**EAST HARTFORD-GLASTONBURY
ELEMENTARY MAGNET SCHOOL PHASE 2
GLASTONBURY, CONNECTICUT
STATE PROJECT NOS. 054-0095 MAG/N/PS & 054-0096 MAG/N/PS
GLASTONBURY BID NO. GL-2011-04**

The following changes to the Drawings and Project Manual shall become a part of the Contract Documents superseding previously issued Drawings and Specifications to the extent modified by this Addendum No. 5. Bidders shall ensure this addendum is acknowledged in the appropriate space provided on the Bid Form when submitting their bid.

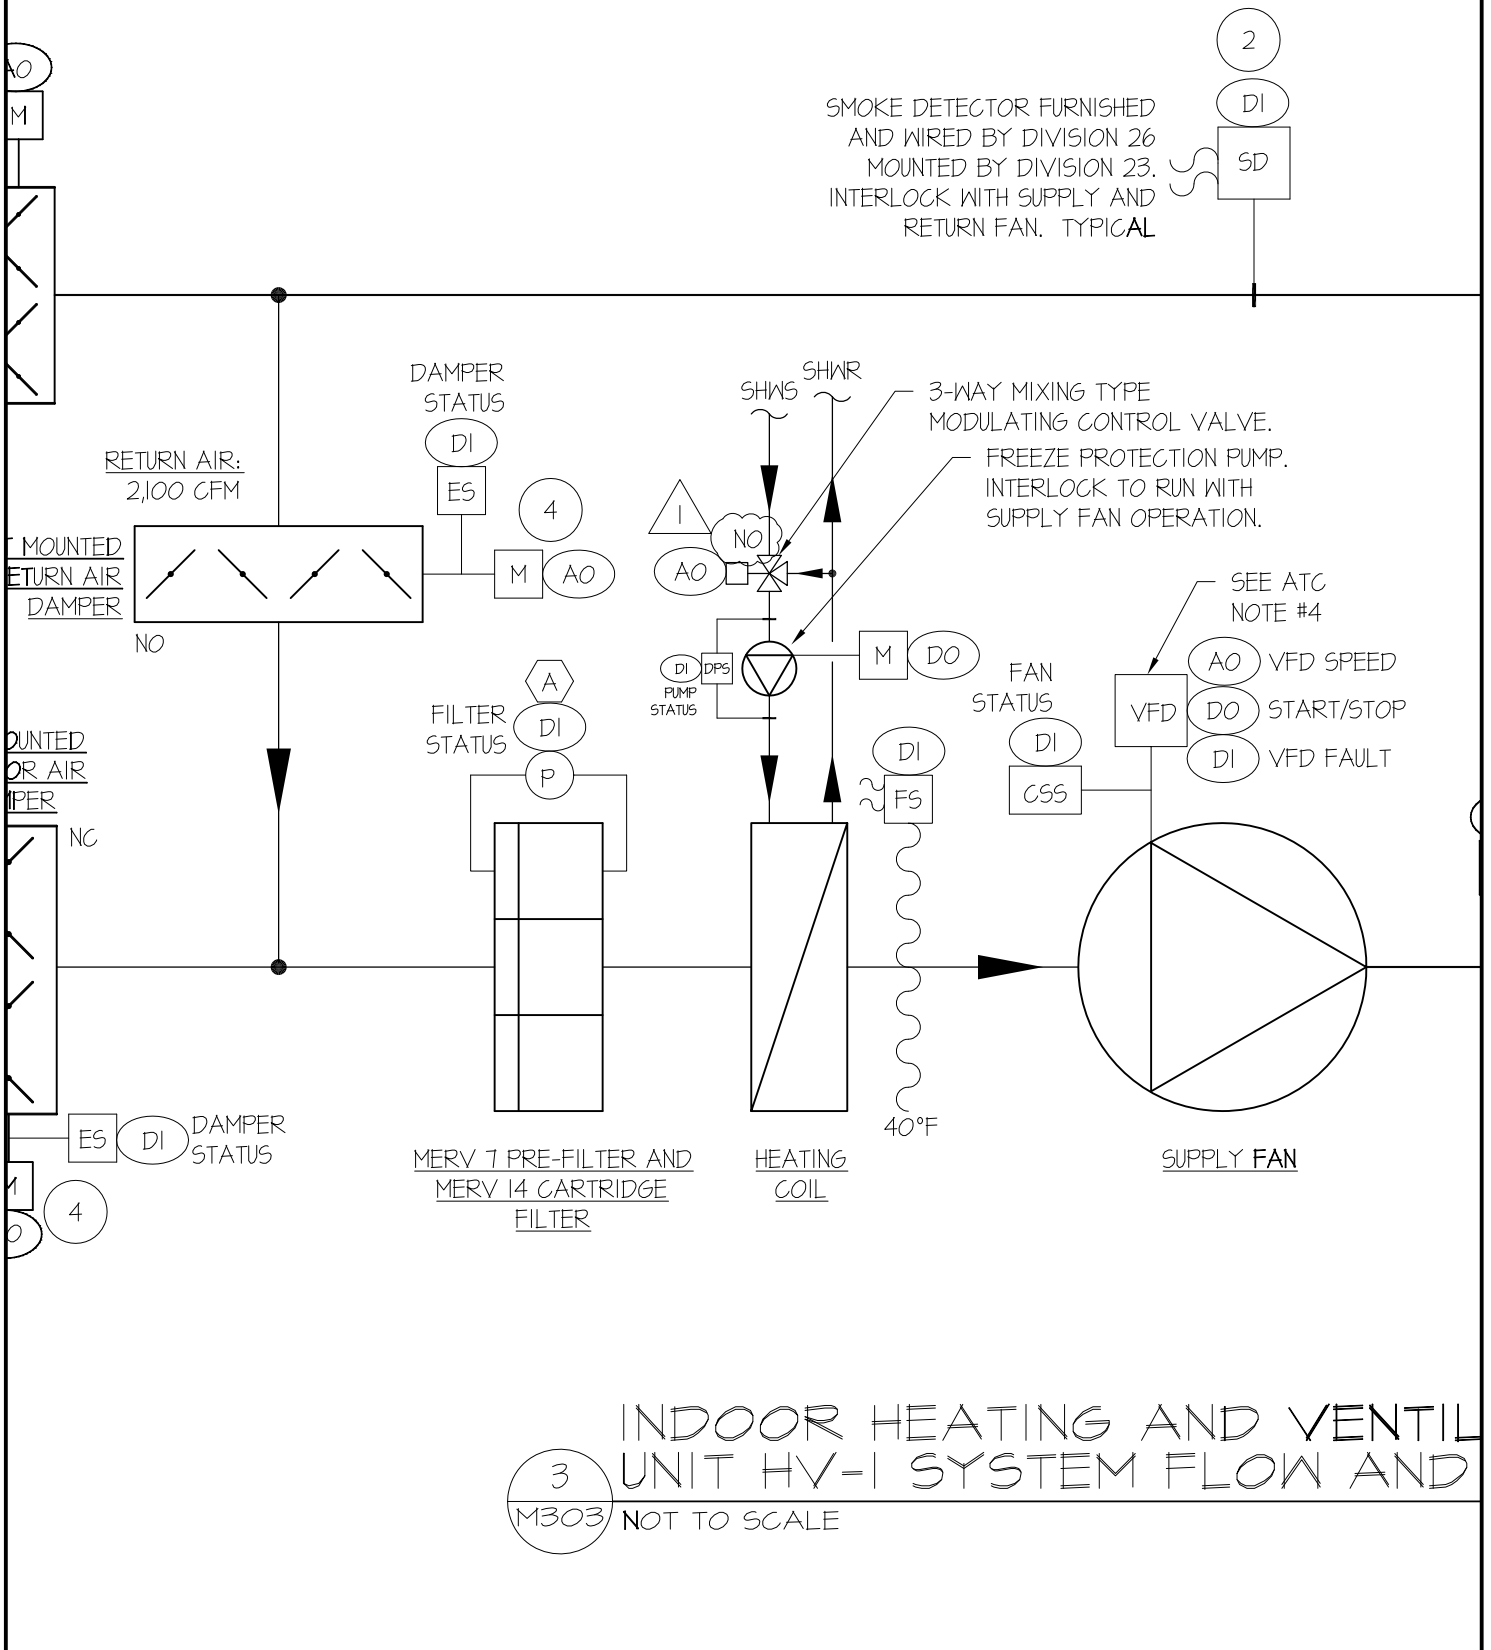
- H. DRAWING NO. M-303 – HVAC FLOW & CONTROL DIAGRAMS:
- 1) REVISE Normally Closed (NC) heating coil 3-way control valves to Normally Open (NO) on Sketches SK-M-303-1 and SK-M-303-2, dated 2/21/11 (copy attached).

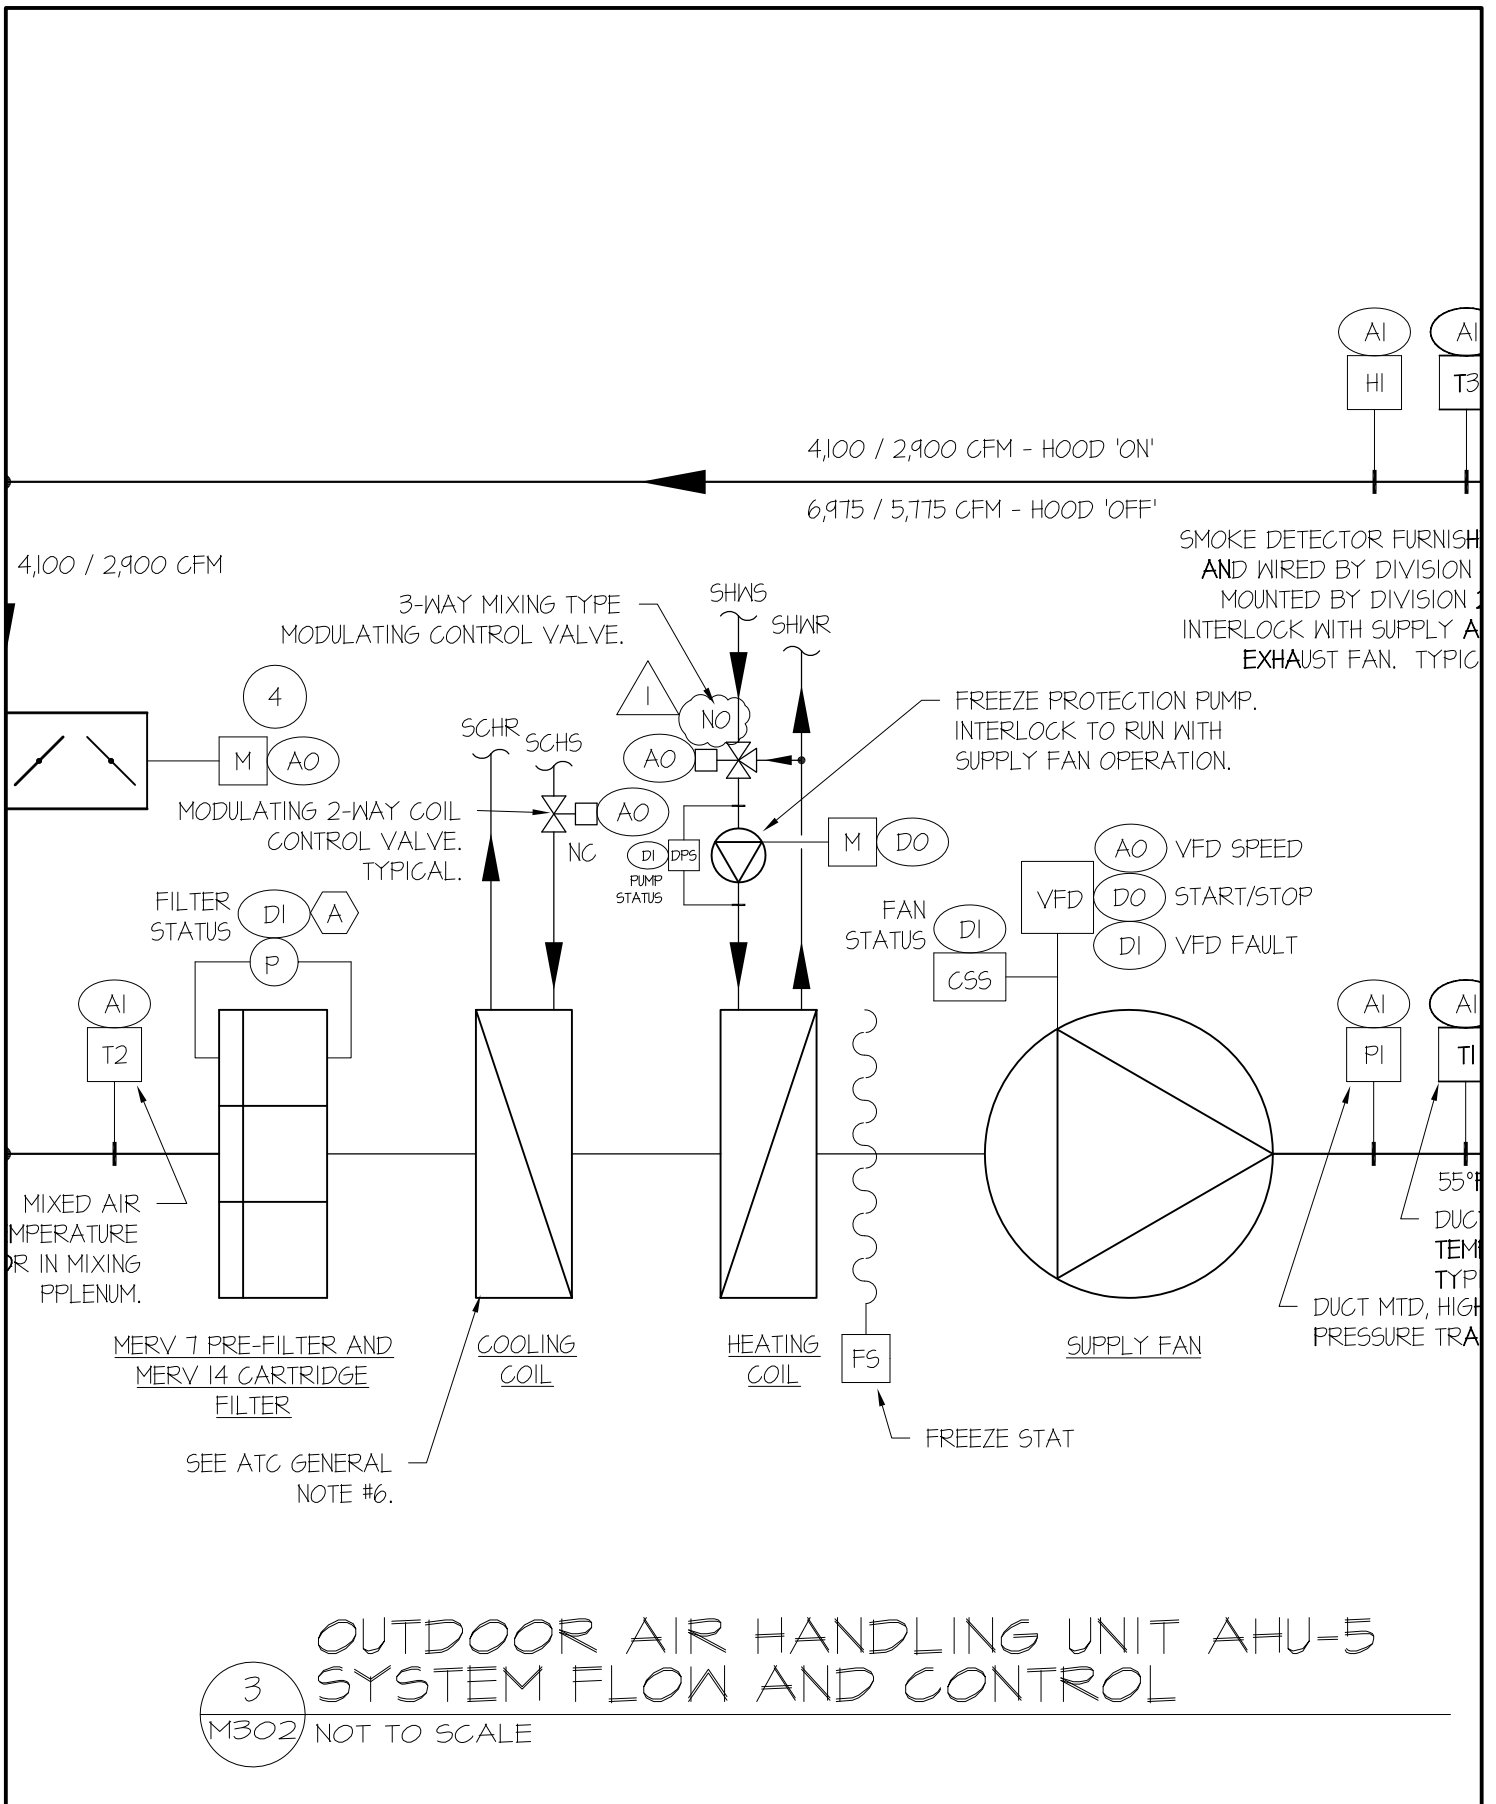
- G. DRAWING NO. M-302 – HVAC FLOW & CONTROL DIAGRAMS:
- 1) REVISE Normally Closed (NC) heating coil 3-way control valves to Normally Open (NO) as indicated on Sketch SK-M-302-1 through SK-M-302-3, dated 2/21/11 (copies attached).

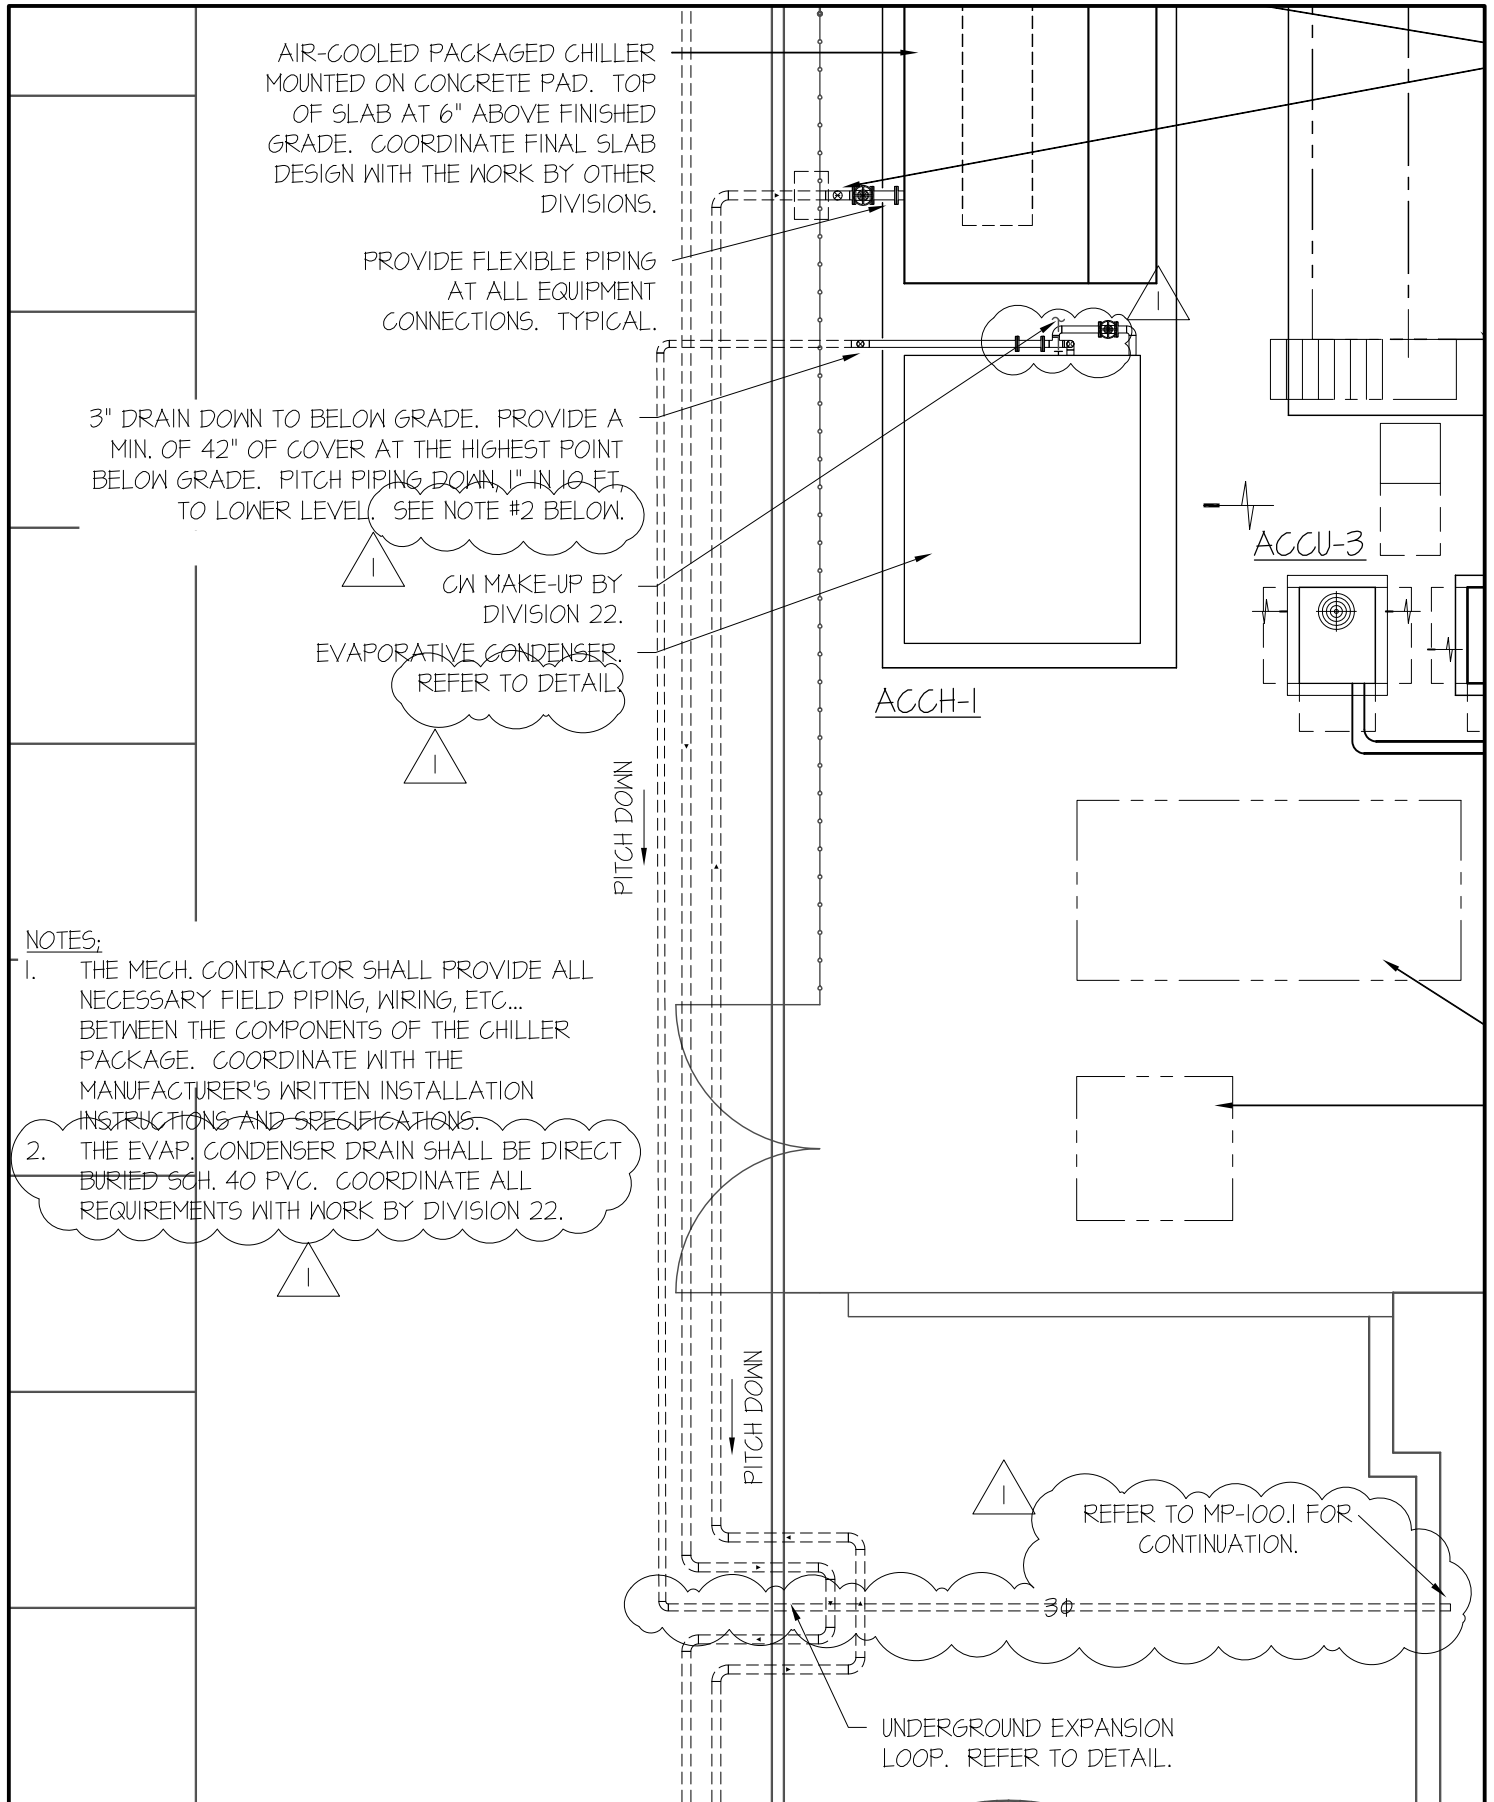
- 1) Revise location of 3" drain into Lower Level as indicated on Sketch SK-M-204-1 dated 2/21/11 (copy attached).

- 2) REVISE piping arrangement at evaporative condenser to eliminate a flexible piping connection and to include a 3" gate valve in unit drain. INDICATE a reference to a new evaporative condenser detail.
